Access Compliance Report Public Rights-of-Way (Curb Ramps)

Main Street: DONNIE_ANN_RD **Cross Street: DONNIS RD** NW Location:

ADA ID: RPRK220217172305 Ramp Type:Type 1 - Perpendicular Diagonal Initial Pass/Fail: Pass **Overall Compliance: No Severity Score:**

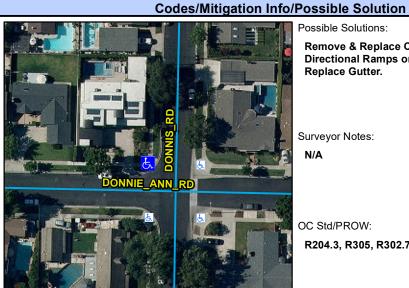
R204.3, R305, R302.7, R304.5.4, STD 1115

Field Measureme	ents/C	Comp	onent Compliance	
	Com	pliance Description	Data	Com	pliance Description	Data
	N/A	Ramp Length (in)	84	N/A	Flare Type LT	
	Yes	Ramp Width (in)	48			Sloped
	Yes	Ramp Run Slope (%)	7.8	N/A	Flare Slope LT (%)	8.6
	Yes	Ramp Cross Slope (%)	0.7	N/A	Flare Traversable LT	No
	N/A	Landing Present	Yes	N/A	Flare Type RT	
	N/A	Landing Length (in)	48			Sloped
	Yes	Landing Width (in)	48	N/A	Flare Slope RT (%)	8.5
	Yes	Landing Run Slope (%)	1.4	N/A	Flare Traversable RT	No
	Yes	Landing Cross Slope (%)	0.1	No	DWS Provided	No
	N/A	Landing Movement Obstructed?	No	N/A	DWS Contrast	N/A
		Landing Movement Type	N/A	N/A	DWS Length (in)	N/A
	N/A	Landing Shared	No	N/A	DWS Full Width	N/A
	N/A	Clear Space	Yes	N/A	DWS Offset Left (in)	N/A
	N/A	Clear Space To Crosswalk (in)	48	N/A	DWS Offset Right (in)	N/A
2	N/A	Marked Crosswalk 1	No	N/A	Marked Crosswalk 2	No
		Crossing 1 Direction	S		Crossing 2 Direction	E

D		Marked Crosswalk 1 Width (in)	N/A		Marked Crosswalk 2 Width (in)	N/A
l	N/A	Ramp Inside Crosswalk 1	N/A	Yes	Ramp Inside Crosswalk 2	N/A
D		Crossing 1 Slope (%)	4.8		Crossing 2 Slope (%)	5.1
l		Crossing 1 Cross Slope (%)	0.7		Crossing 2 Cross Slope (%)	1
	No	Gutter Ponding	Yes	Yes	Curb Slope	0.9
	Yes	Gutter Lip Height (in)	0		Road Run Slope (%)	1.3
	No	Gutter Run Slope (%)	5.3		Road Cross Slope (%)	6
<u>a</u>	Yes	Gutter Cross Slope (%)	1.3			
0	Yes	Overall Surface Condition: Accep	otable	No	Perp Joint Present	No
		Cross Gutter Present?	No		Spandrel Present?	No
Α		Replace Cross Gutter?	N/A		Replace Spandrel?	N/A

Remove & Replace Curb Ramp With Two New Directional Ramps or Equivalent. Remove & Replace Gutter.
